Upper San Diego River Improvement Project Final Programmatic Environmental Impact Report

July 2000, Revised August 2000

LOG NO. 98-10-014
SCH# 98041146

Attached is the Final Programmatic Environmental Impact Report (EIR) for the Upper San Diego River Improvement Project (USD RIP), as certified by County of San Diego Board of Supervisors on August 9, 2000, as Agenda Item #1. This printed version incorporates all errata provided at the hearing and, for readability purposes, has been produced in "clean" form (with no underline/strikeout text). **PLEASE NOTE THAT THE BOARD OF SUPERVISORS ADOPTED THE RIVERWAY SPECIFIC PLAN ALTERNATIVE (WITH MINOR MODIFICATIONS), AND NOT THE PROPOSED PROJECT AS PRESENTED IN THE EIR.** This alternative, which is discussed in detail in Section 4.6 of the EIR, was designated as the environmentally preferred alternative, and was the Staff and Planning Commission recommended alternative. The Board of Supervisors made the following modifications to the alternative prior to adoption:

Fig. 1-4
Proposed Land Use Zones

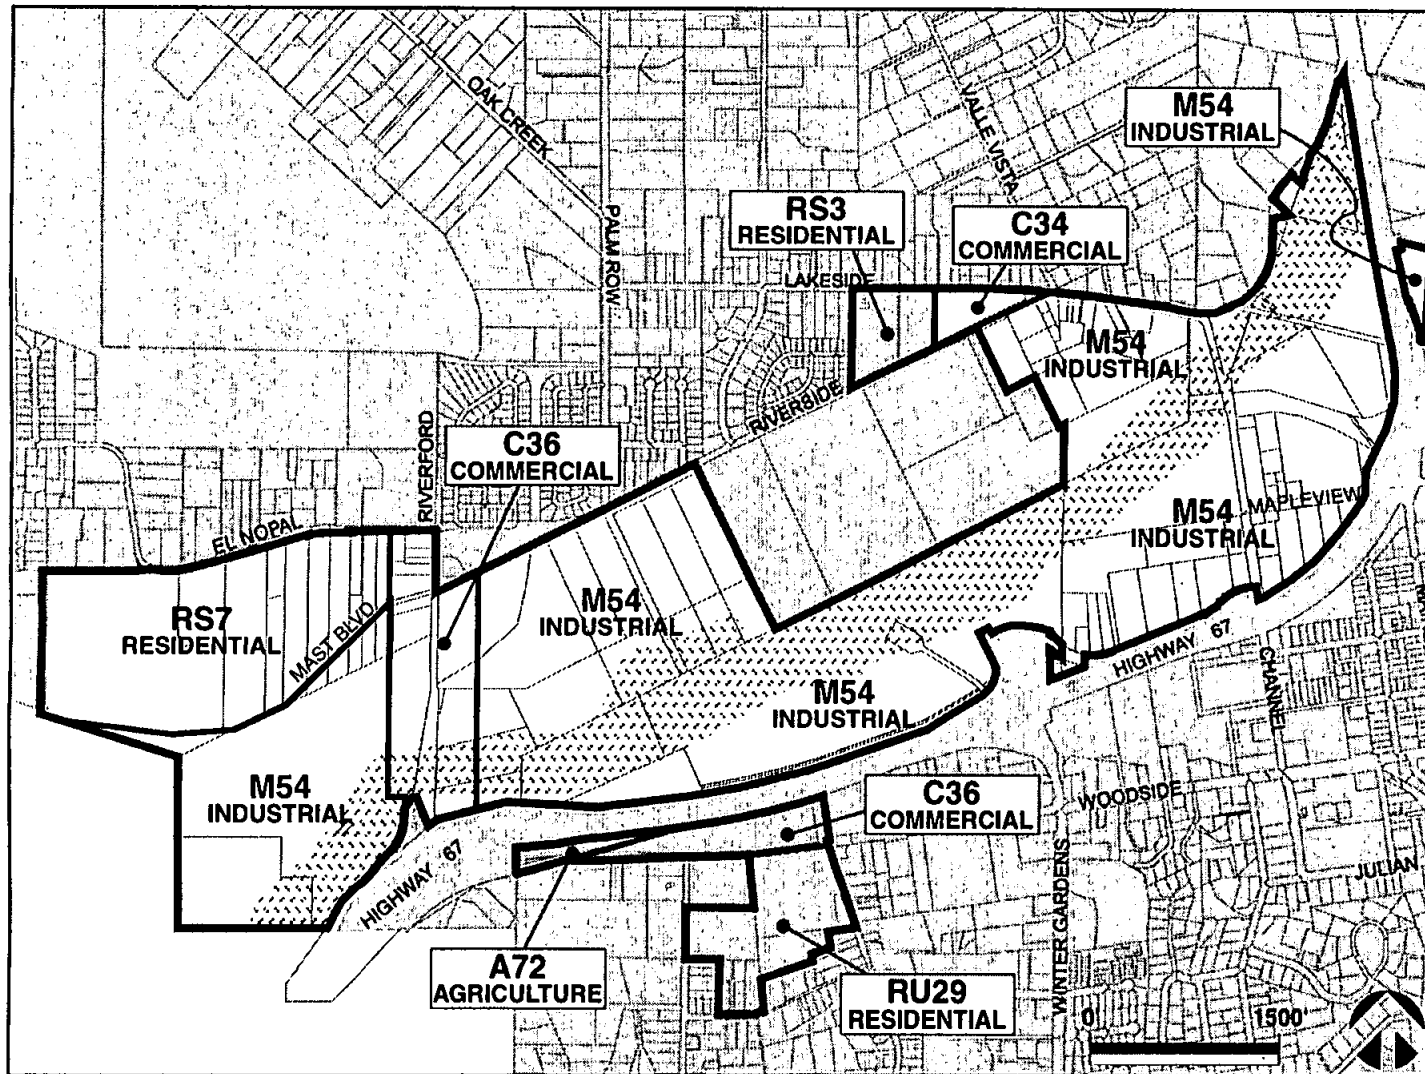
After review of the EIR, and consideration of the comments contained herein and in the enclosed letters from Grabhorn Engineering Corp. and Pacific Southwest Biological Services, Inc., of the alternatives presented in the EIR, we support the Proposed Land Use Zones as detailed in Figure 1-4 therein.

Fig. 2.2-2
**Areas Subject to
 Regulatory and
 Discretionary Actions
 Affecting Biological
 Resources**

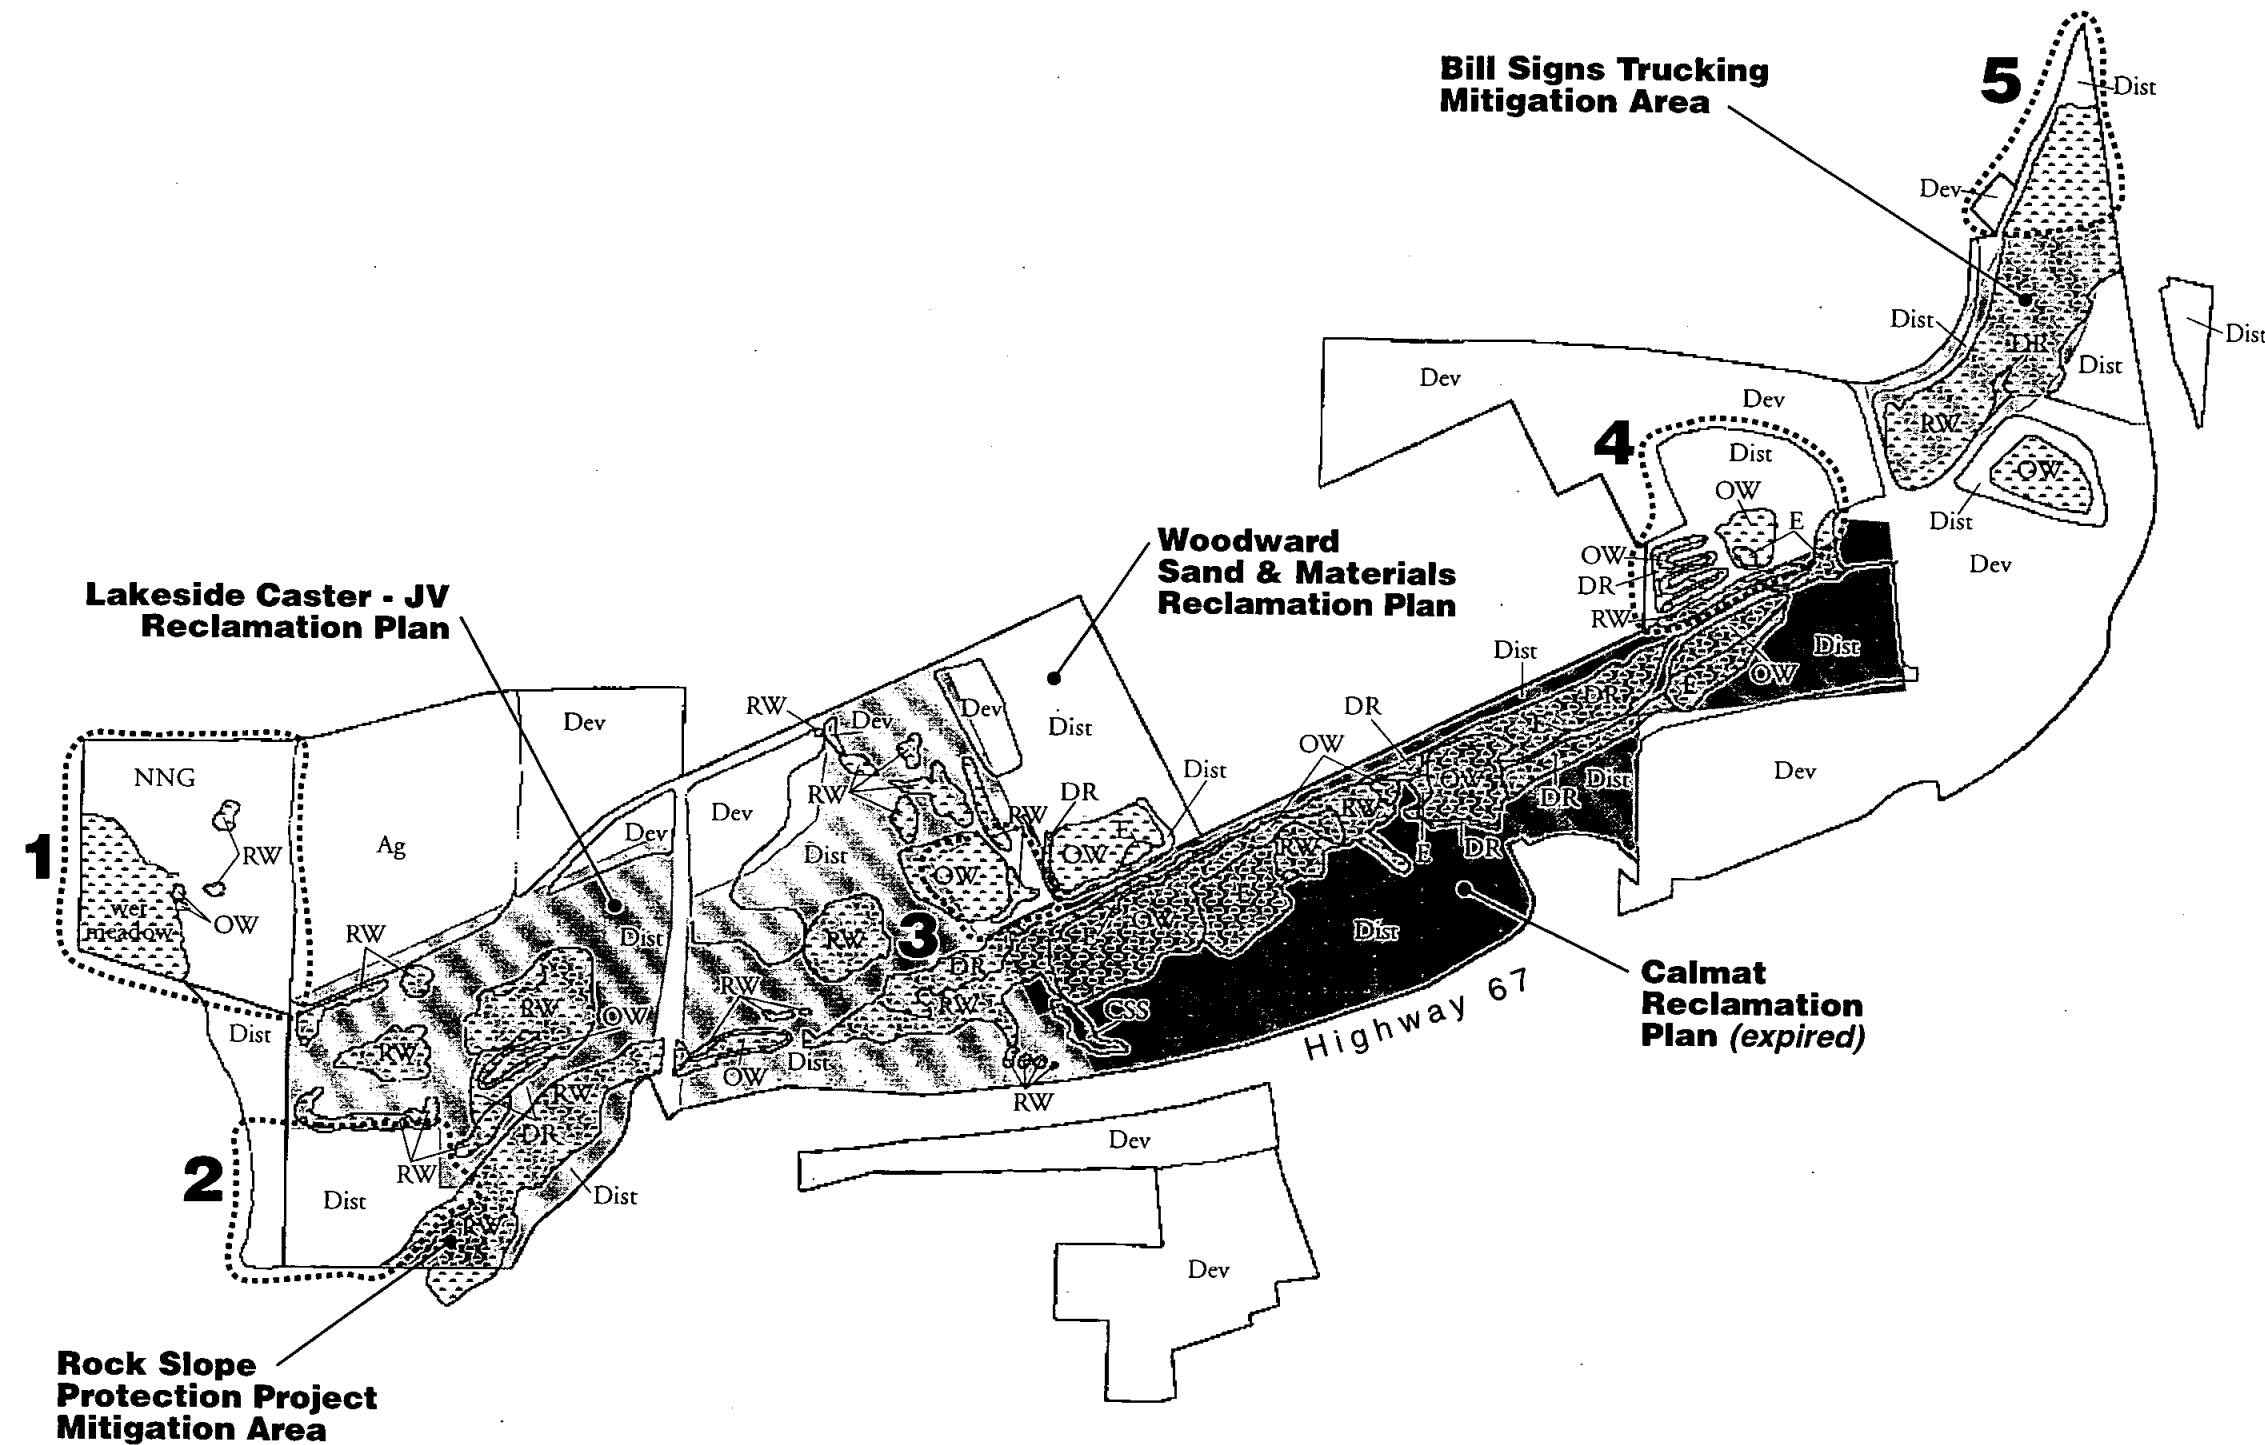
3. The area identified as "Area 3" at page 2.2-10 and in figure 2.2-2 is part of RP97-001. Thus, mitigation has already been imposed for development impacts in this area.

We are concerned about the characterization of the biological resources in Area 1 (designated as Area I in the RiverWay Specific Plan (referred to in the DEIR on page 2.2-10). The document contains the following statement(s): "In the northwest corner of the site (Area 1 on Figure 2.2-2), there is a 30 acre parcel that is currently dominated by ruderal grassland and wet meadow. Several large willow trees are also present that probably remain from the time when the entire floodplain was at the same approximate elevation. This site is designated as Planning Area I in the RiverWay Specific Plan. Development in this area would result in a loss of more than five acres of potential wetland. In addition, a California gnatcatcher pair (federally listed as threatened) was observed in the southwest corner of this parcel. The birds primarily utilized habitat off-site to the south, but were noted perching on shrubs at the property boundary. Development of this parcel could impact this species which would be considered a significant impact."

A-6: Three areas within the USDRIP area were identified that would have the potential to be significantly impacted by future development projects allowed within the USDRIP project area. These areas are identified on Figure 2.2-2 and discussed on page 2.2-10 of the Draft EIR. Wetland impacts from the flood control plan approved for the RiverWay Specific Plan were to be mitigated by the revegetation requirements contained in the RiverWay Specific Plan (see pages 2.2-10 and 2.2-11 of the Draft EIR); however, since the RiverWay Specific Plan would be repealed, the mitigation measures specific to that plan would no longer be required unless specifically mandated under the terms and conditions of existing permits. The following are mitigation measures to replace the RiverWay Specific Plan (page 2.2-11 of the EIR):

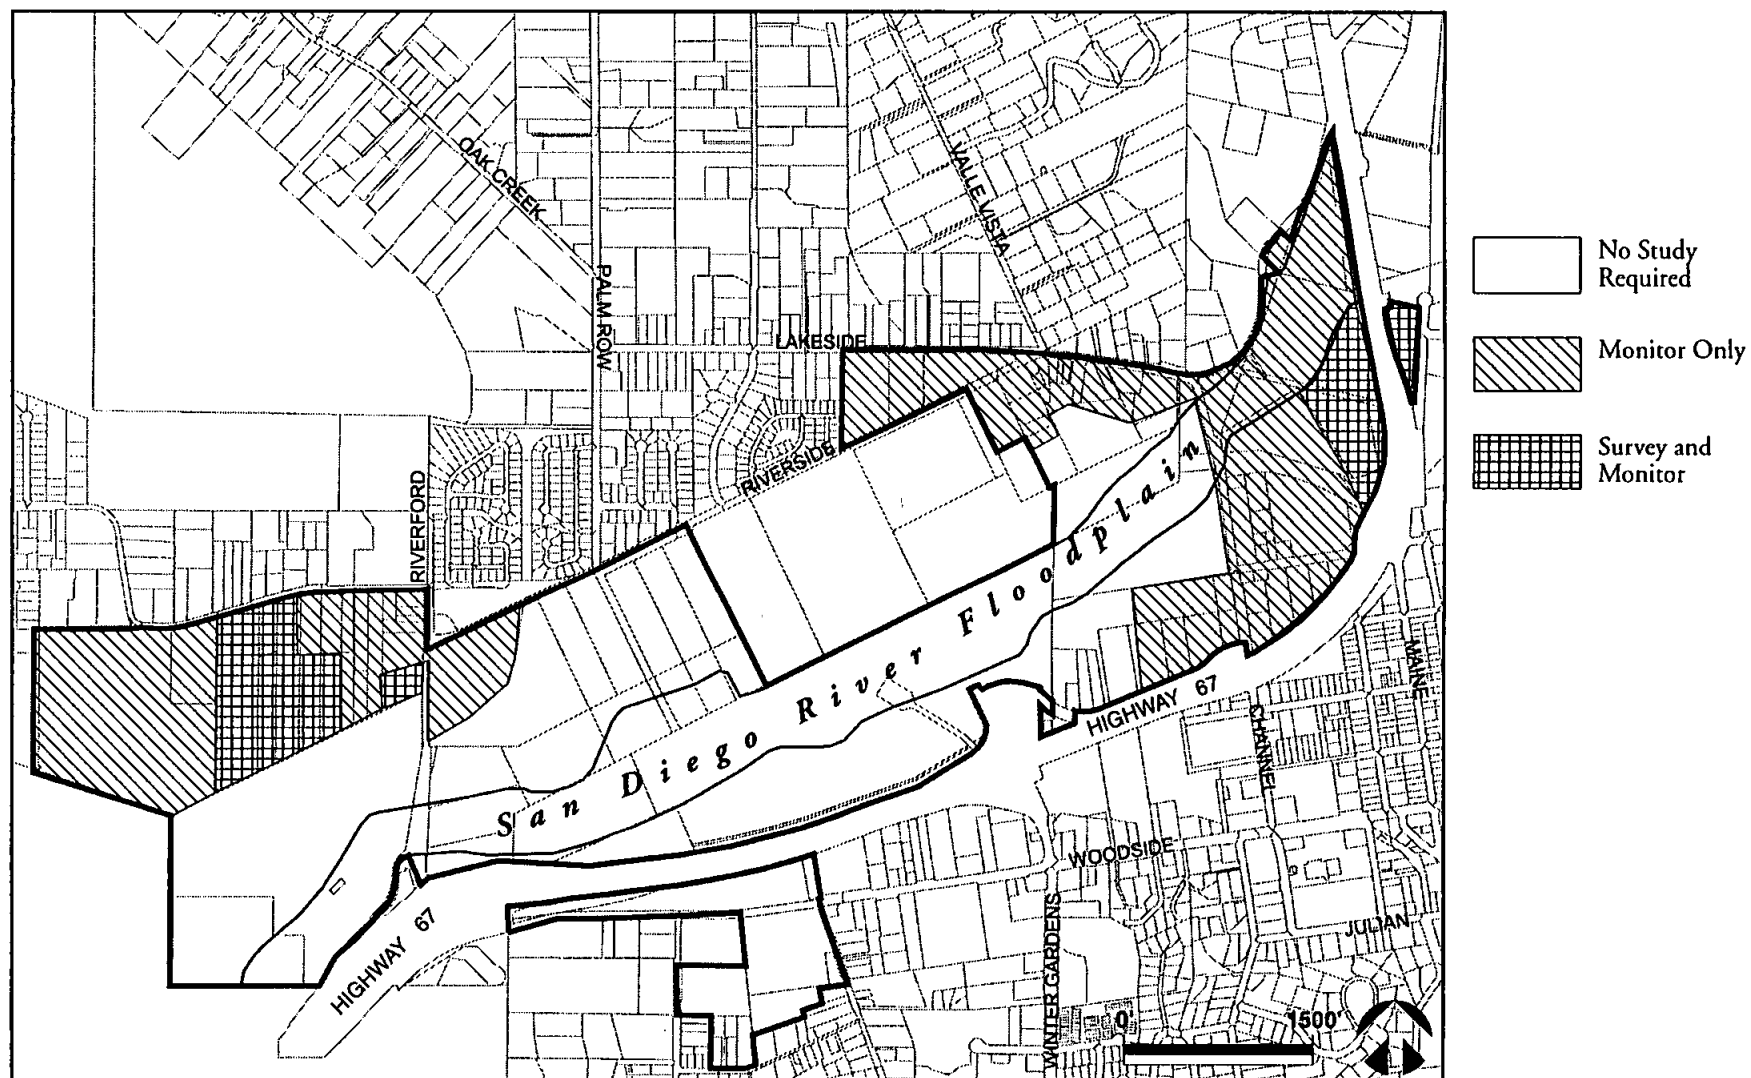
- (1) Figure 2.5-1 includes the annotation "Source: Brian F. Mooney Associates 1989." This is beyond the County's normal 5 year horizon for updated cultural resources reports and analyses. Therefore, the figure should be reviewed and updated as appropriate.
- (2) The cultural resources mitigation measures cited in the DEIR omit any requirement for curation. The attached copy of the SDCAS Policy on Curation provides relevant information.

Fig. 4.4-1
M52 Buffer Alternative

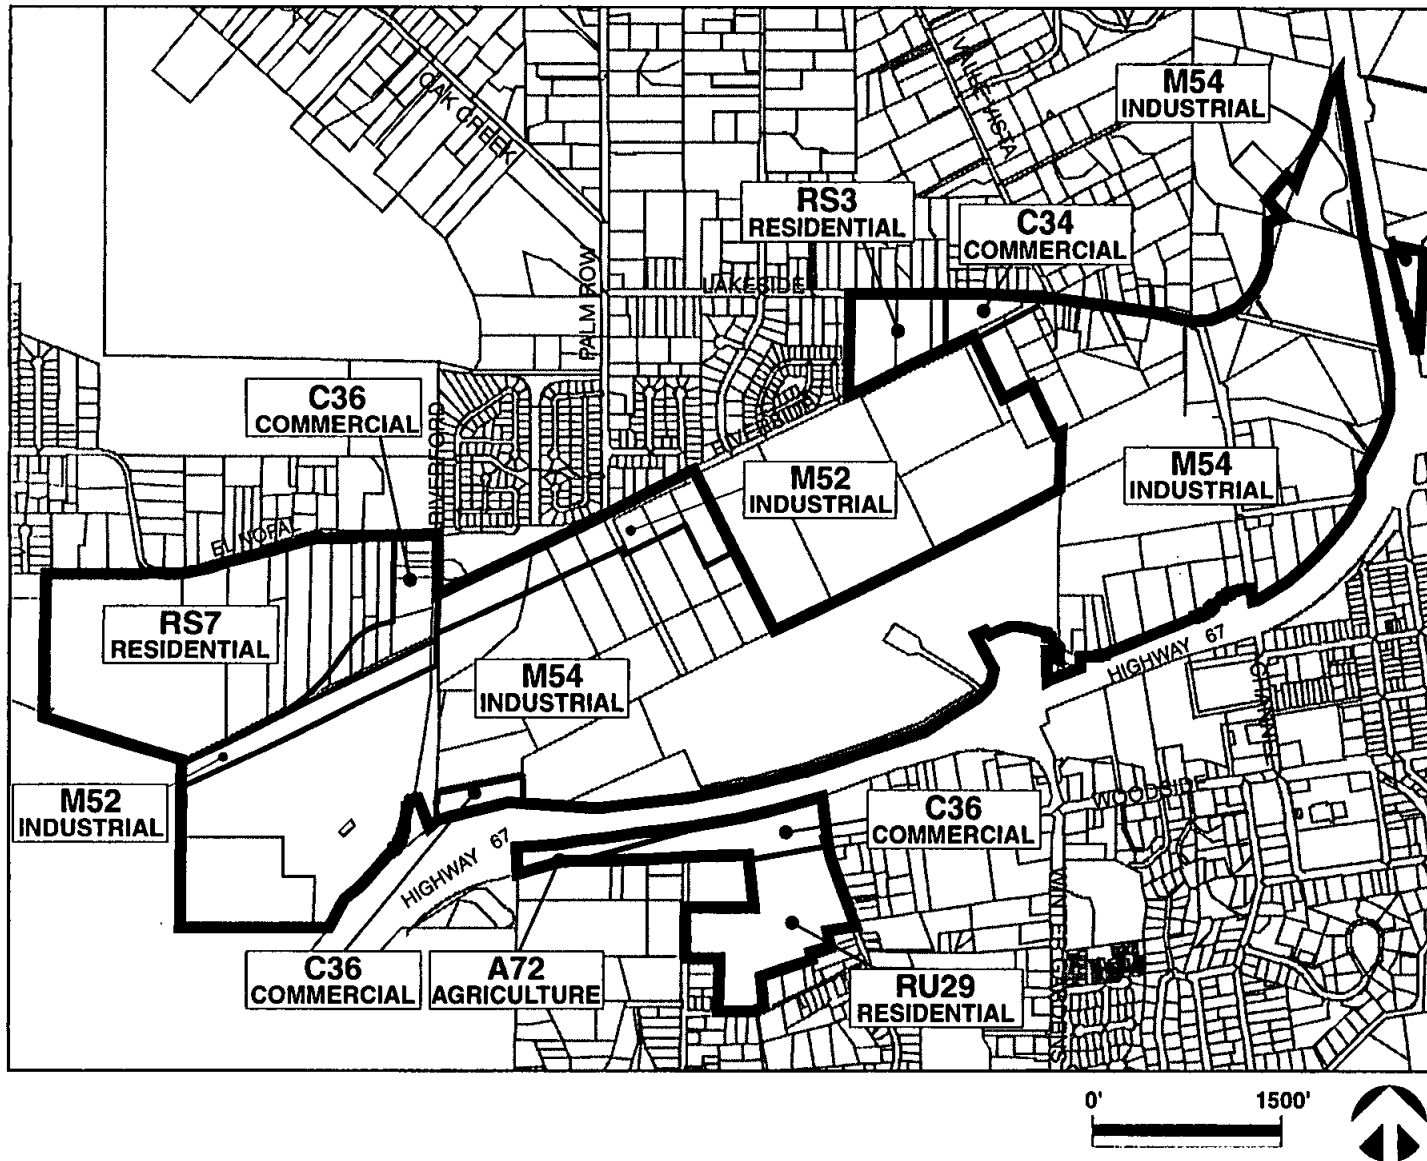
17. On page 4-9, Section 4.4.1, second line and on page 4-9, the fourth sentence of the third paragraph in Section 4.4.2, the reference to Figure 4.5-1 should be changed to refer to Figure 4.4-1.

The M52 zoning of the property south of Mast Blvd. as reflected in the M52 Buffer Alternative (Figure 4.4-1), appears to be environmentally superior over the M54 zone, while still meeting the proposed project's objectives. Therefore, in the best interest of the community, the south side of Mast should be zoned with an M52 buffer, without affecting the proposed C36 zone at the Mast Blvd., Riverside Drive, and Riverford Road intersection.

Analysis of the M52 Buffer Alternative Description and Setting Sections 4.4.1 and 4.4.2 refer to Figure 4.5.1 for the M52 Buffer Alternative. Figure 4.4.1 appears to address this alternative, not 4.5-1.
